Technical Bulletin

Cabriolet Top Motor

Number
9608

Models Affected: **911 Carrera Cabriolet as of Model Year 1996**

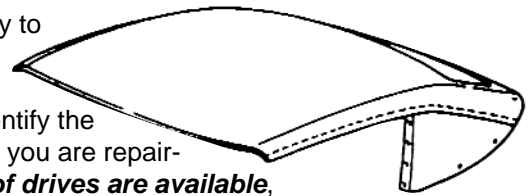
General Information: The cabriolet top is now driven by a single drive motor (formerly two motors). This change occurred in production as of December 5, 1995 from VIN 99 6TS 341001.

When repairs are necessary to the cabrio top drive motor, mounting bracket or drive cables, it is important to identify the type of cabrio top drive that you are repairing. **Parts for both types of drives are available,** however, it is possible to install the new single motor drive parts into a vehicle previously equipped with two drive motors. This repair requires the use of the new drive motor parts (drive motor, drive cable left, drive cable right, mounting bracket left and mounting bracket right). It is not possible to combine old and new drive motor parts.

SINGLE DRIVE MOTOR - NEW VERSION

993 624 117 00	Electric drive motor
993 561 921 01	Drive cable, left
993 561 922 01	Drive cable, right
993 624 185 00	Mounting bracket left
993 624 186 00	Mounting bracket right
